REMARKS

Docket No. 0513-1175 Appln. No. 10/582,350

FIG.5

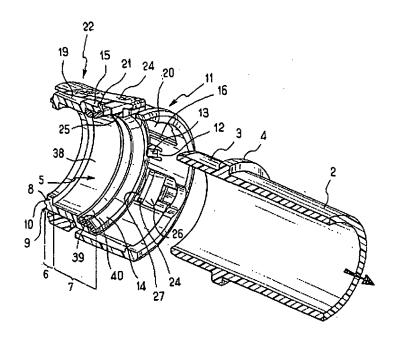
The drawings have been objected to as missing a lead line for reference element "1" in Figure 4 and for not having brackets or dotted lines to designate a complete figure in Figures 5 and 6. The comments in the Official Action have been

The present invention pertains to a quick coupling device that is illustrated, by way of example, in Figure 5 of the application, which is reproduced below.

As is set forth in claim 10 of the present invention, the device includes a tubular body (5) having a connection section (7) arranged to receive in a leaktight manner at one end

considered, and the drawing figures have been appropriately amended.

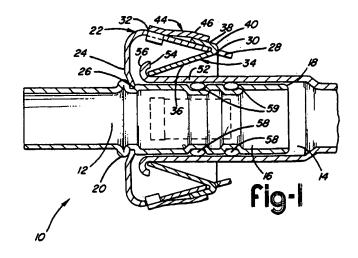
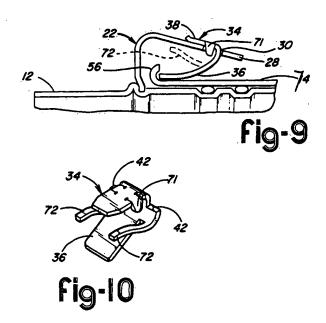
McELROY et al. pertain to a quick connect coupling. The Official Action refers to Figures 1, 9 and 10 of McELROY et al., which are reproduced below.

At page 6 the Official Action asserts that the Retaining members (36) of McELROY et al. are deformable around an axis perpendicular to the central axis of the body (24).

However, in McELROY et al. the retaining members are not pivotable in a holding position in which the retaining member is maintained by a body surface either in its releasing state or it gripping state.
